Model No: **SLB700 (MK2)**

Issue: **TB010**

Model Name: **Ø700mm Marker Buoy**

Image:

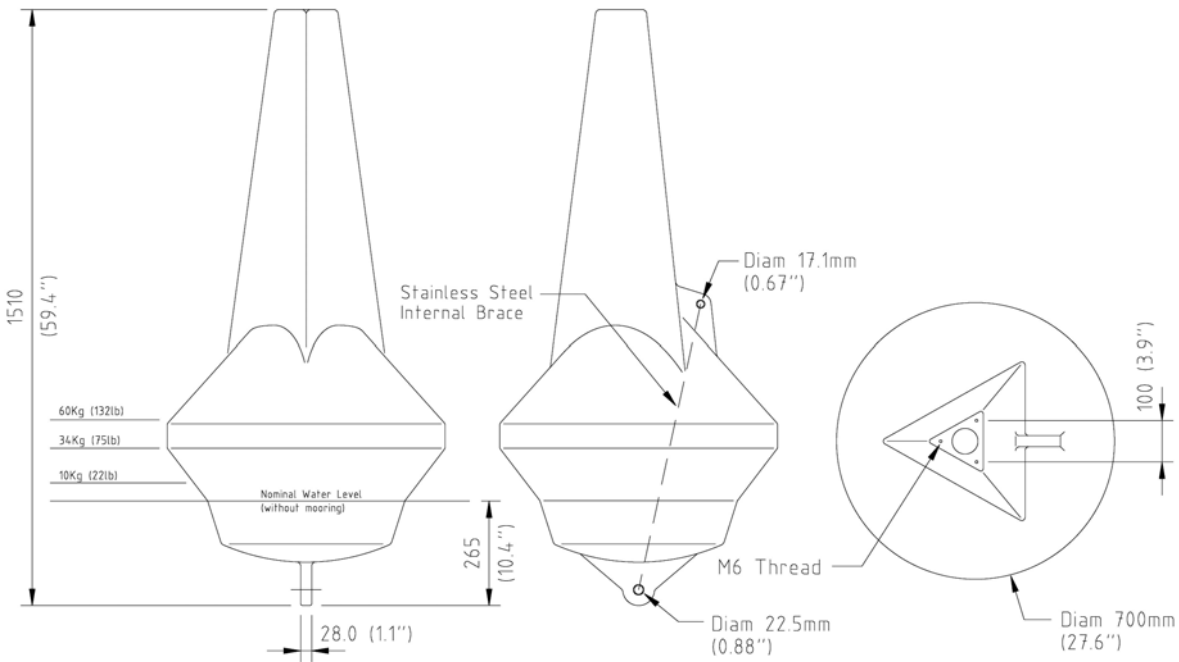
Description of Change	Reason for Change	Effective Date
<p>Changes to Mould Shape</p> <p>Focal Plain Height Increase 100mm</p> <p>Total Float Volume Increased 35L/Gallon</p> <p>Nominal Freeboard - Increased</p> <p>Minimum Freeboard - Increased</p> <p>Nominal Draft - Reduced</p> <p>Maximum Draft - Reduced</p>	<p>Increased Above Water Visibility</p> <p>Increased Focal Plane Height</p> <p>** See Current Product Spec Sheet for further technical details</p> 	<p>October 2011</p>
